**HAM CR 251 0.11
 BLUE ASH RD PH 2**

CITY OF DEER PARK
 HAMILTON COUNTY

REVIEW COMPLETE

STAGE 1 SUBMITTAL - 2/14/2025

CROSS SECTIONS
 STA. 10+50 TO STA. 11+00

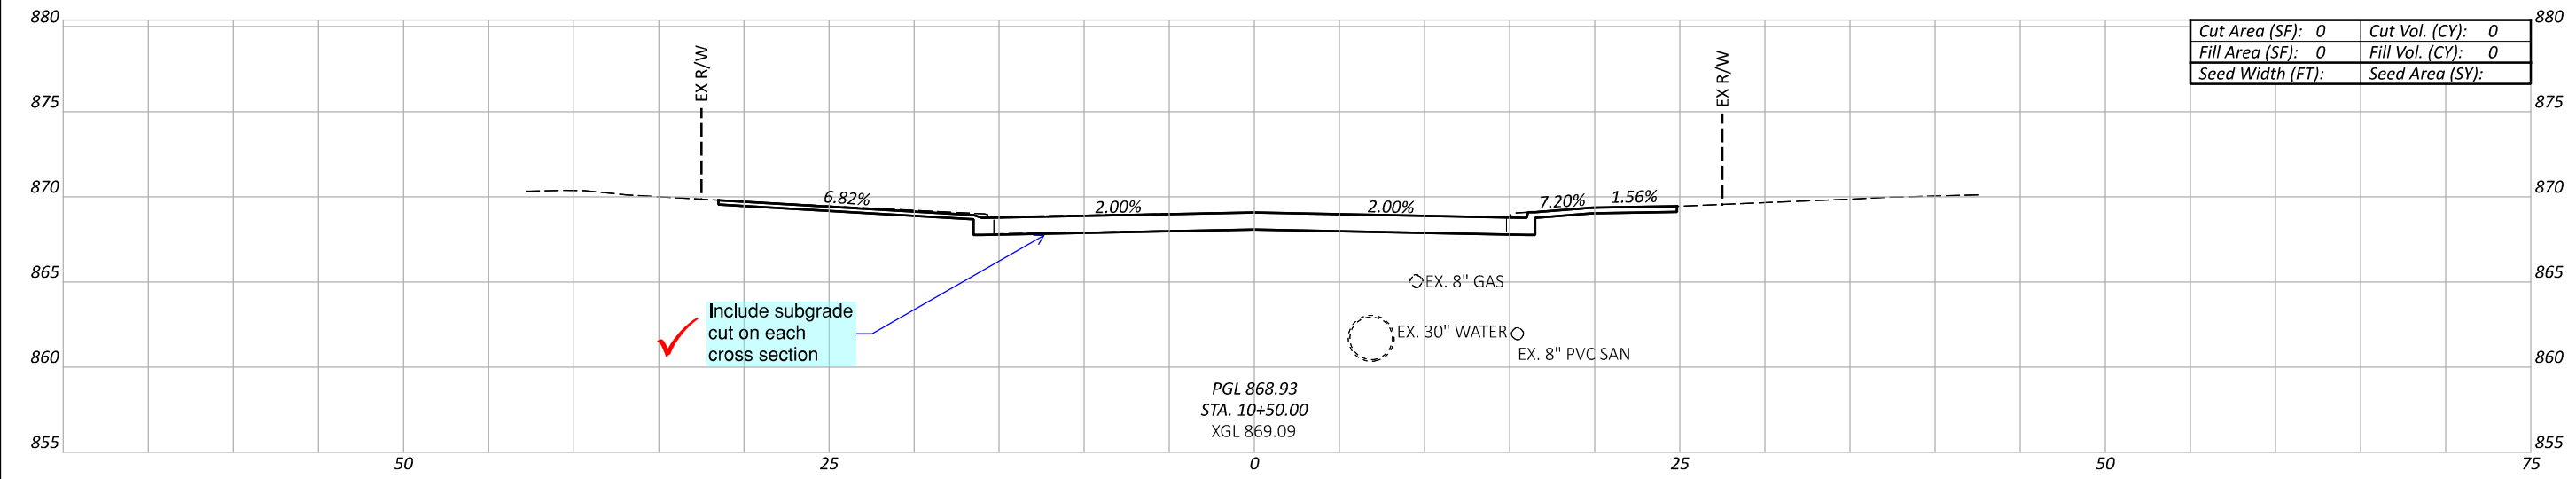
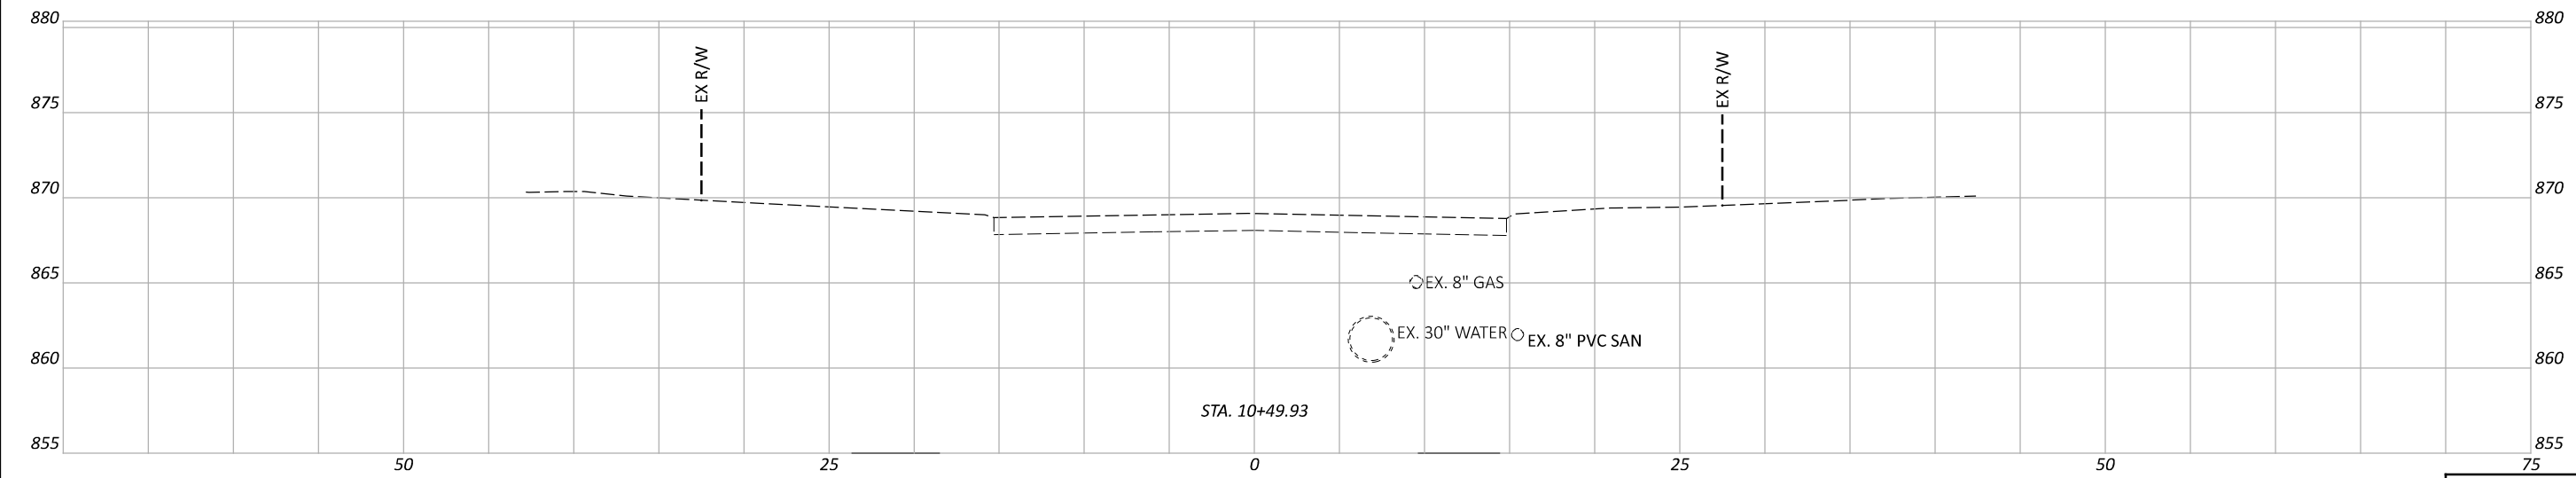
The plan and profile show the proposed work outside of the RW at Sta. 11+00. This needs to be confirmed at each cross section. ✓

✓ Include subgrade cut on each cross section

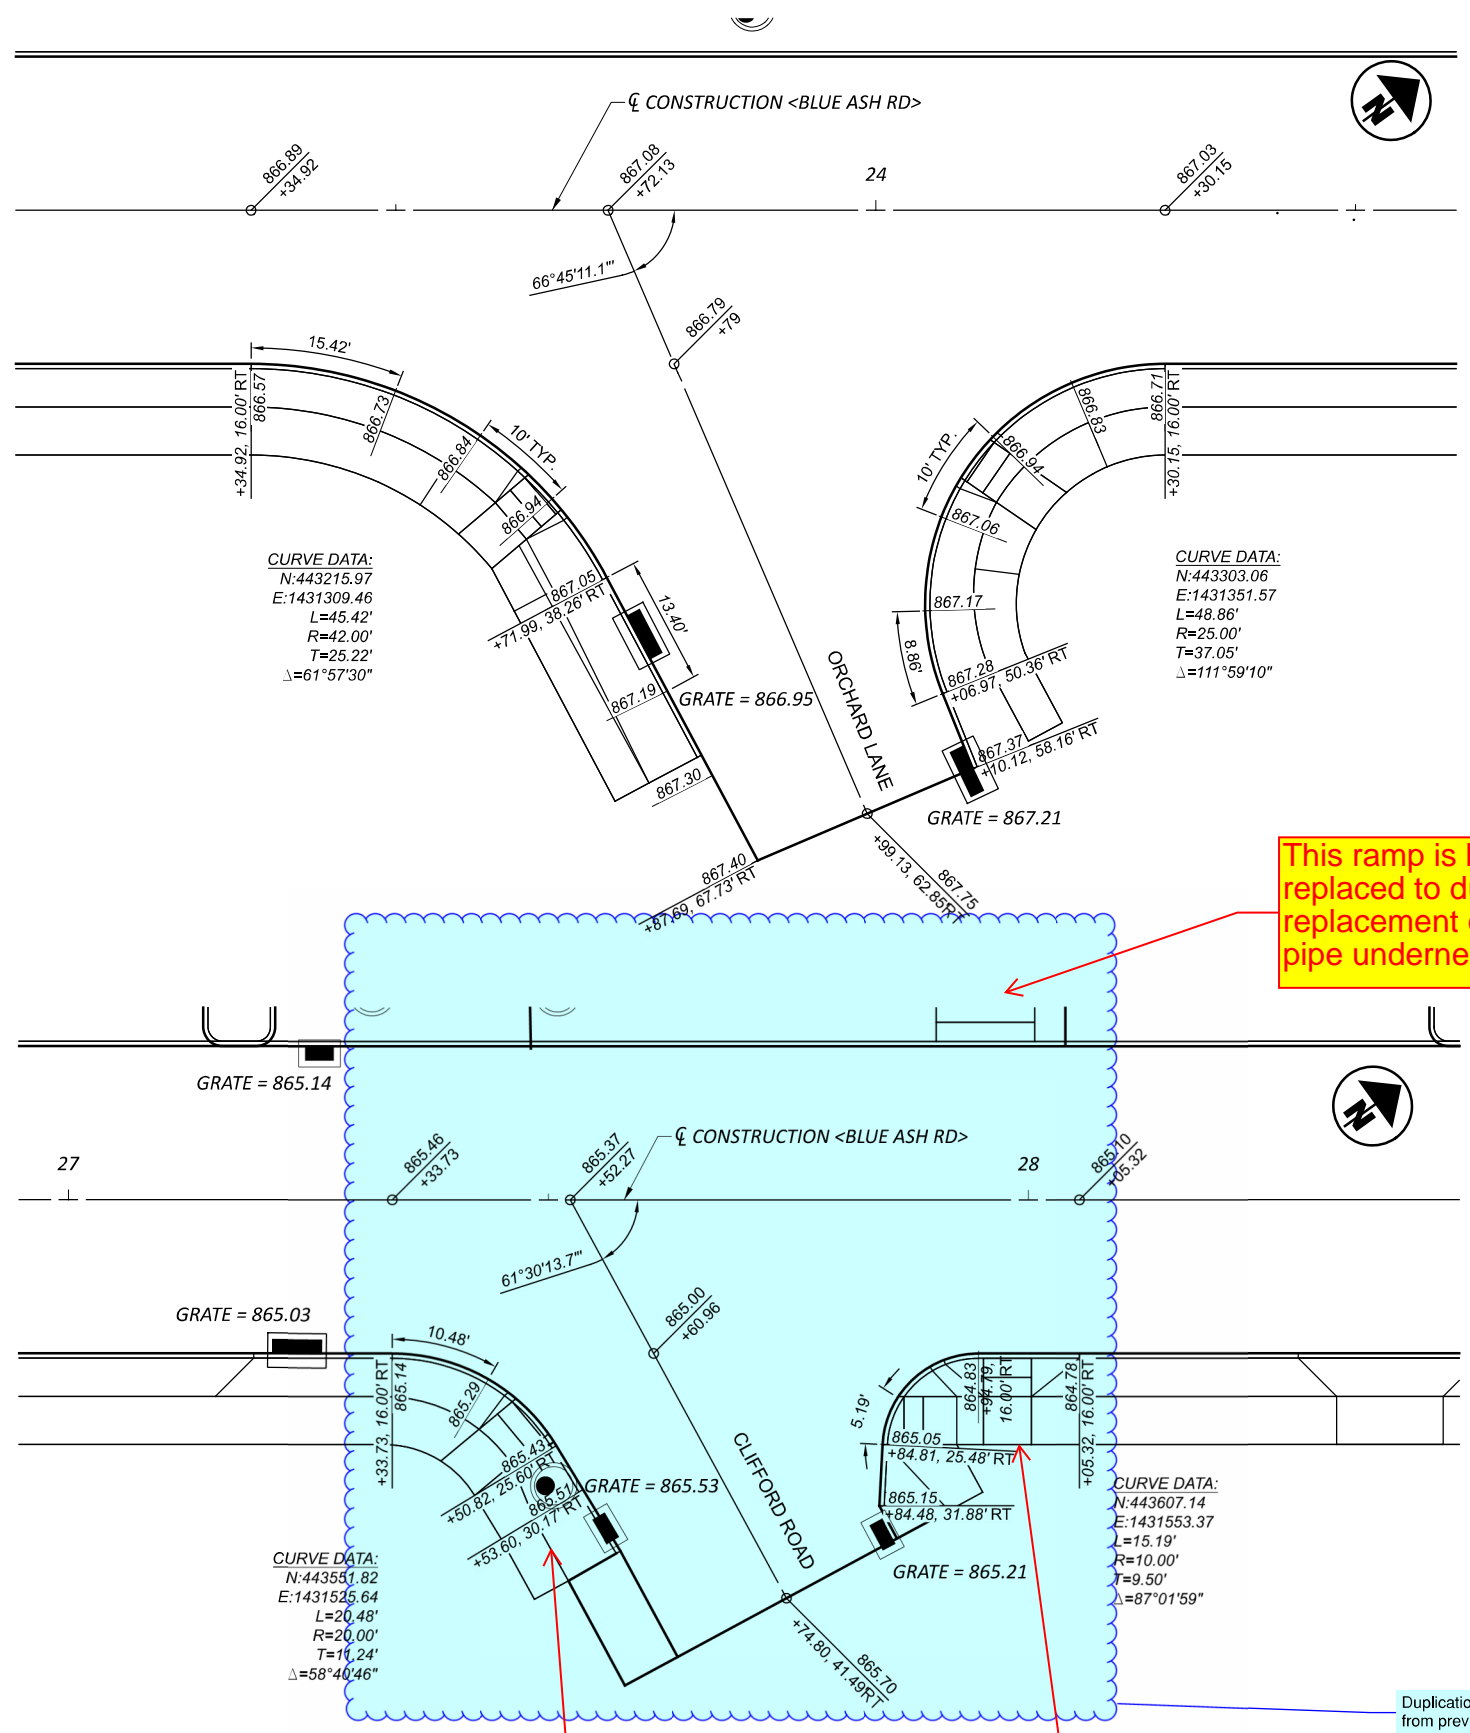
No previous work at this corner.

This ramp is being replaced to due to the replacement of the storm pipe underneath it.

HAM CR 251 0.11 BLUE ASH ROAD PHASE 2
DRAINAGE PROFILES

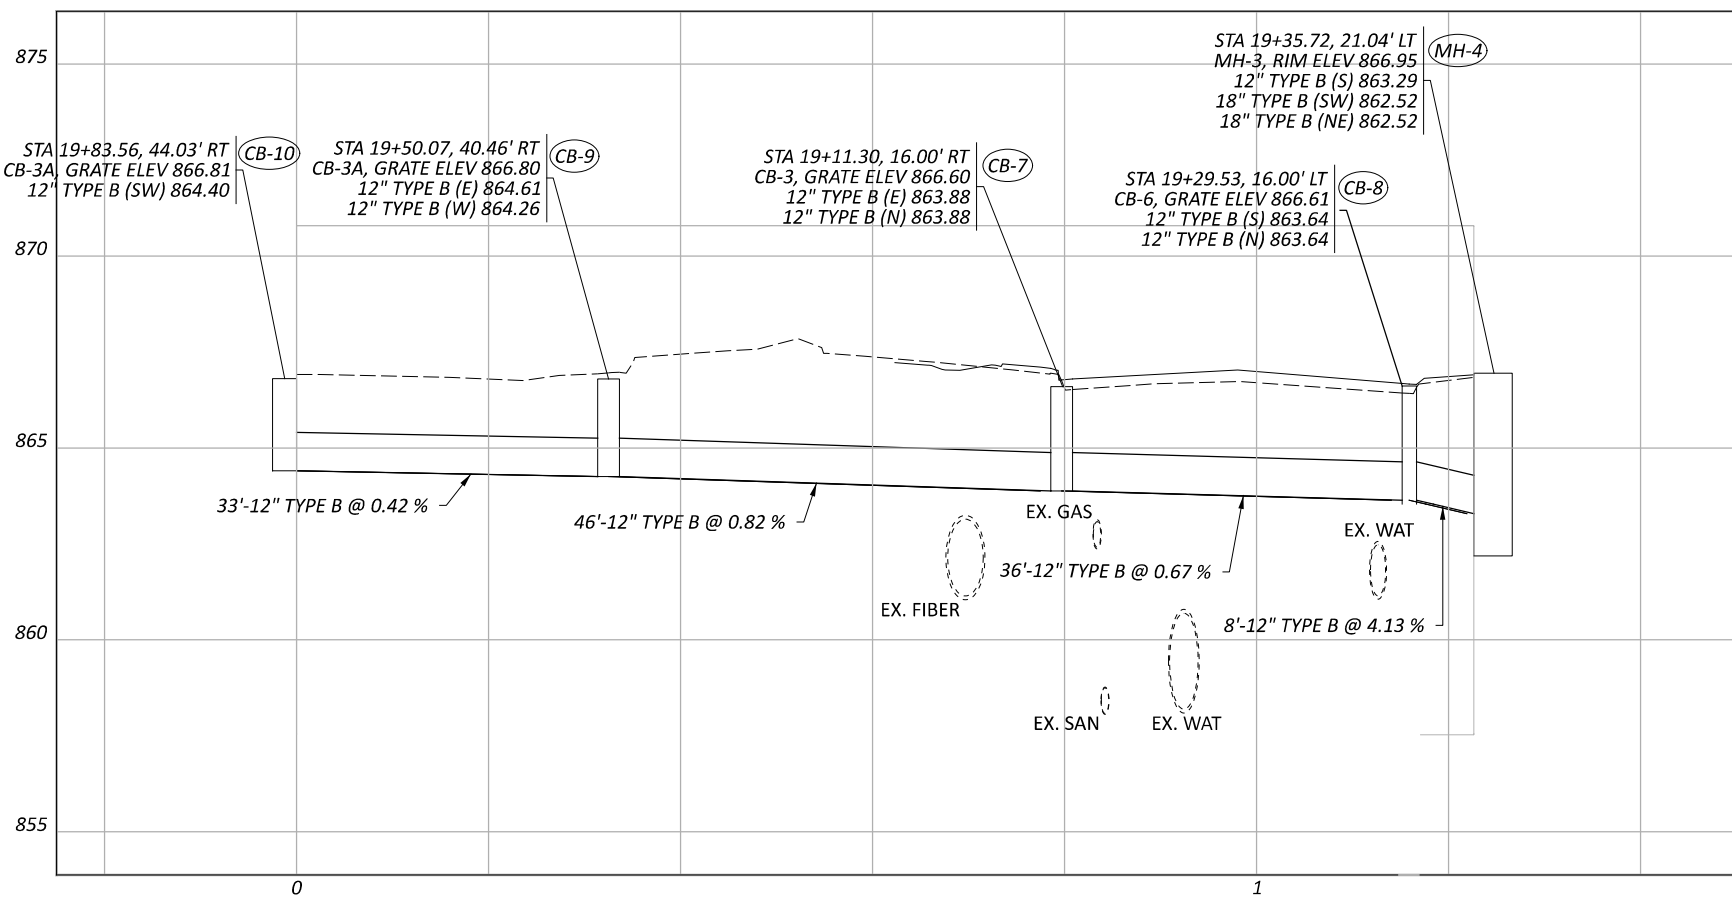
How were depths of the utilities determined? We need potholing or confirmation of depths to determine if the utilities are in conflict

add underdrain flowlines to applicable structures

Altafiber depths are from as-build plans. Gas and water are assumed based on possible depths that avoid the existing storm sewer.

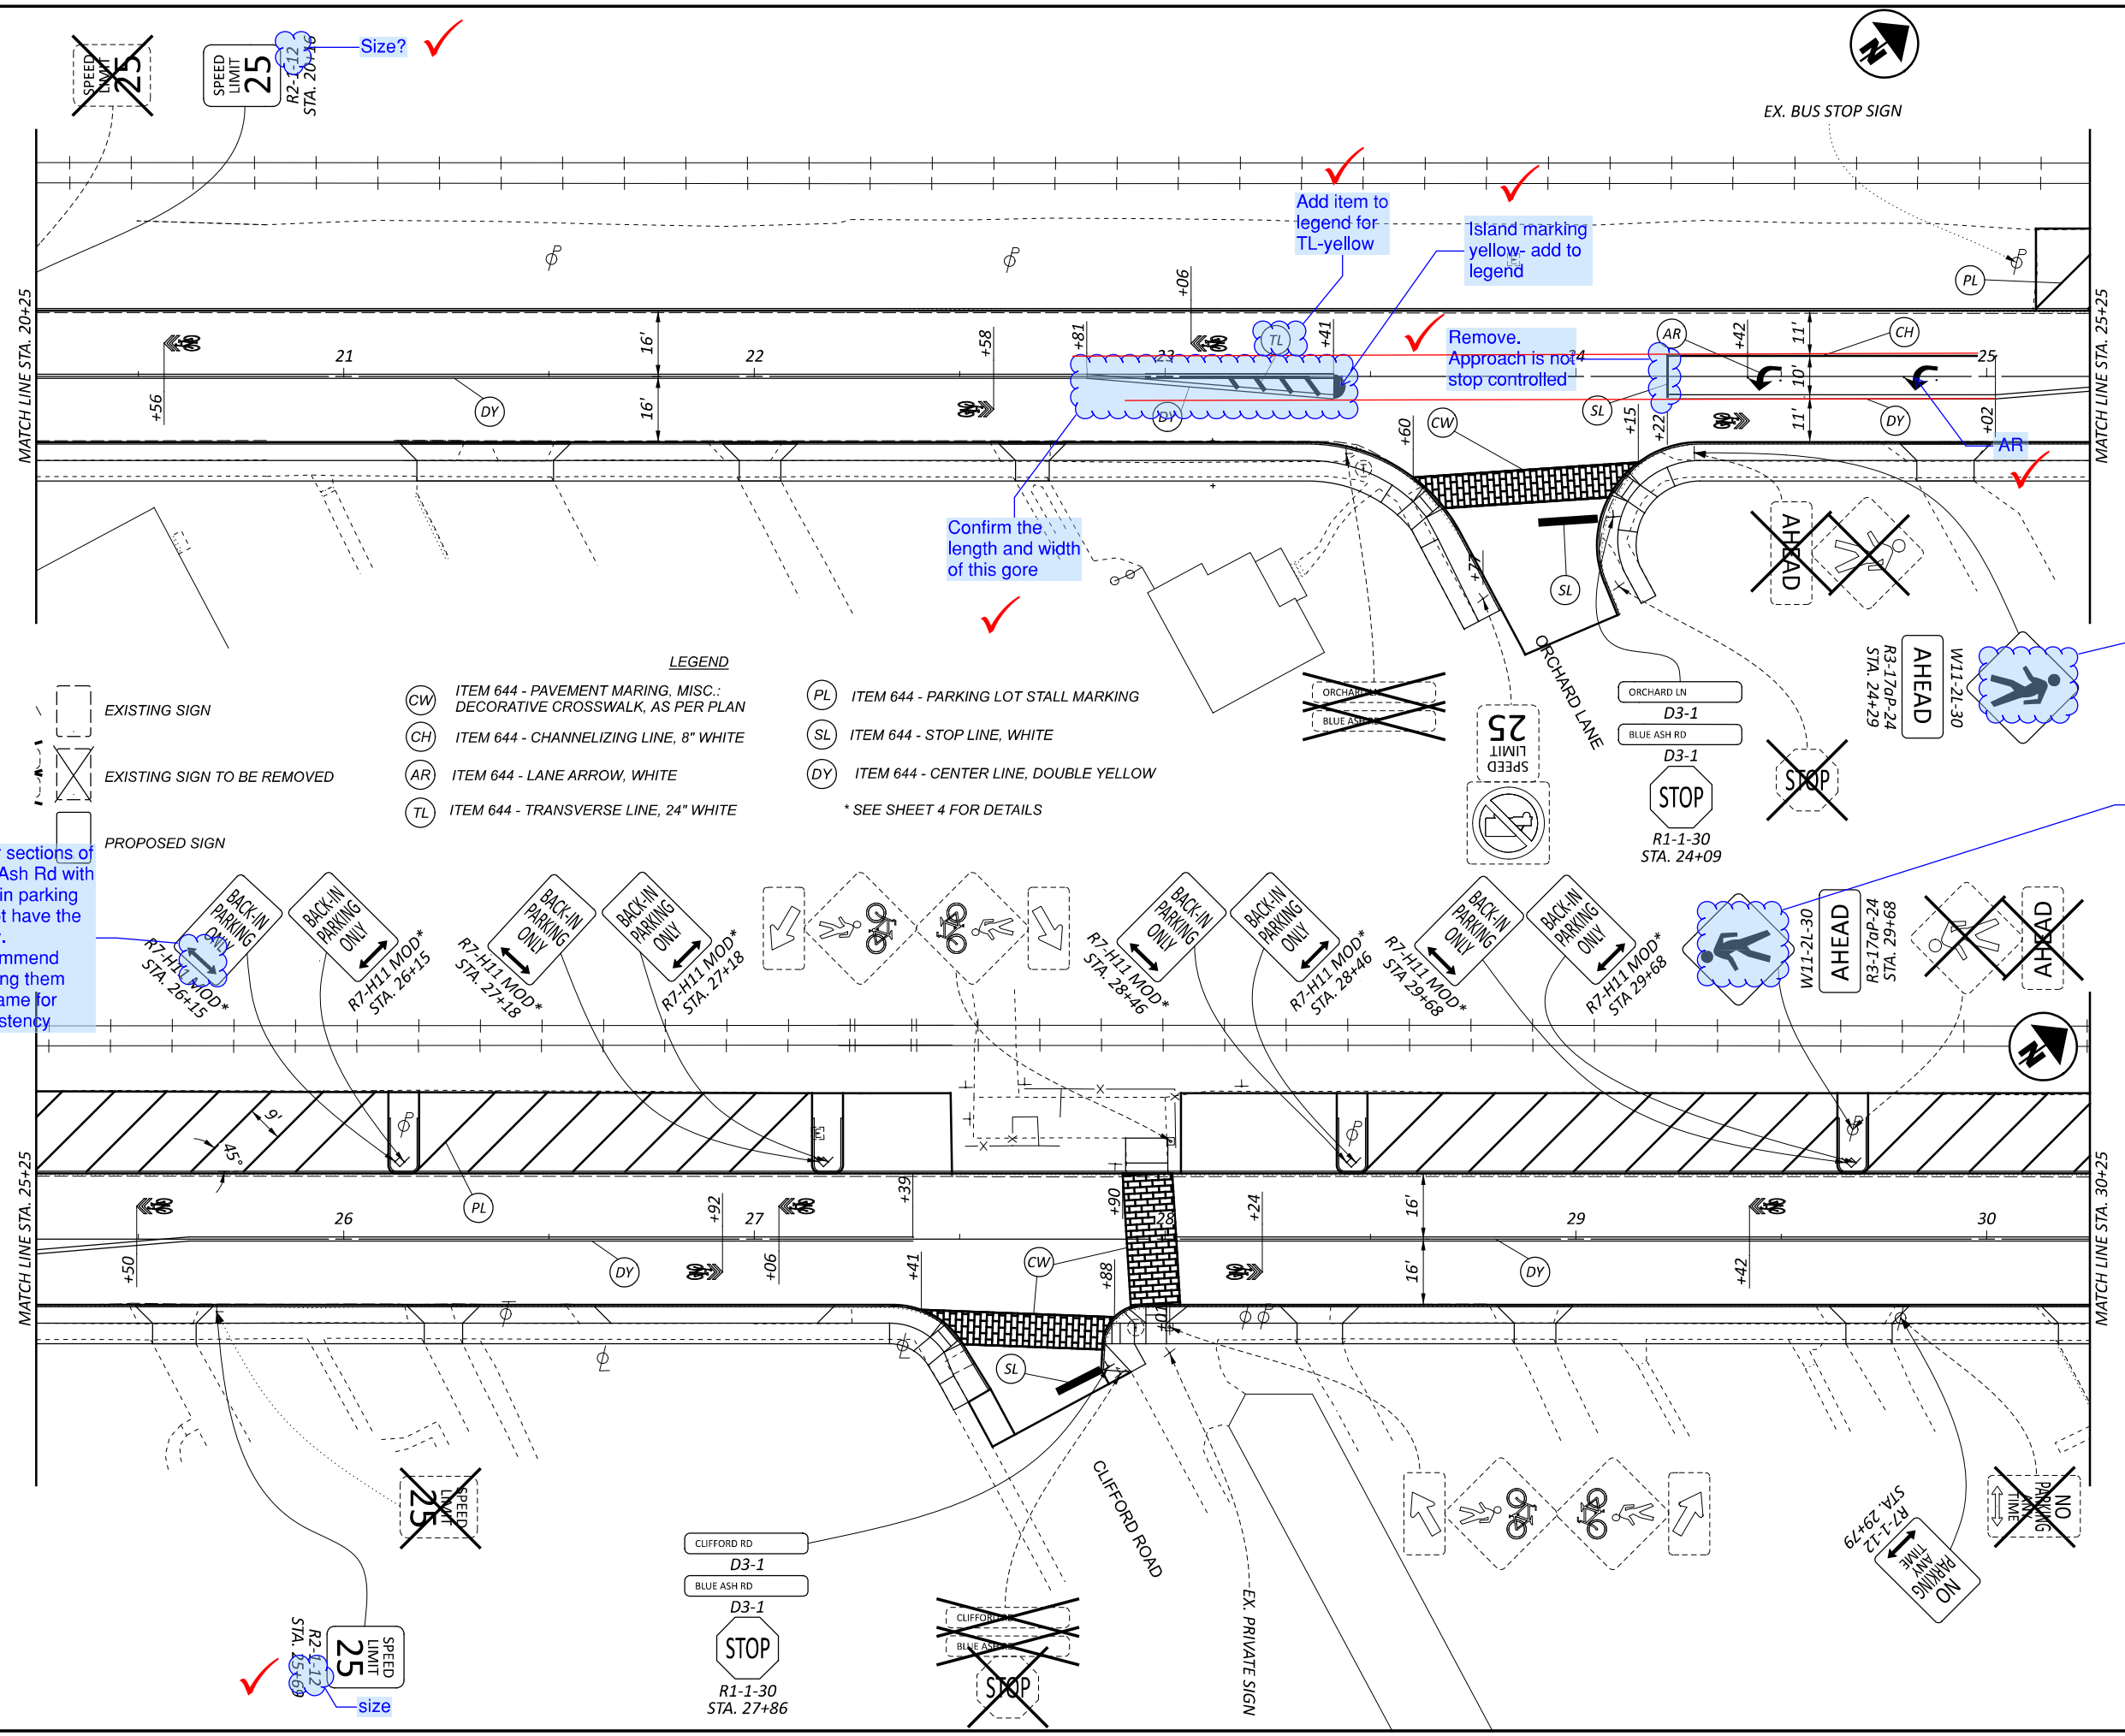
Other sections of Blue Ash Rd with back in parking do not have the arrow. Recommend keeping them the same for consistency
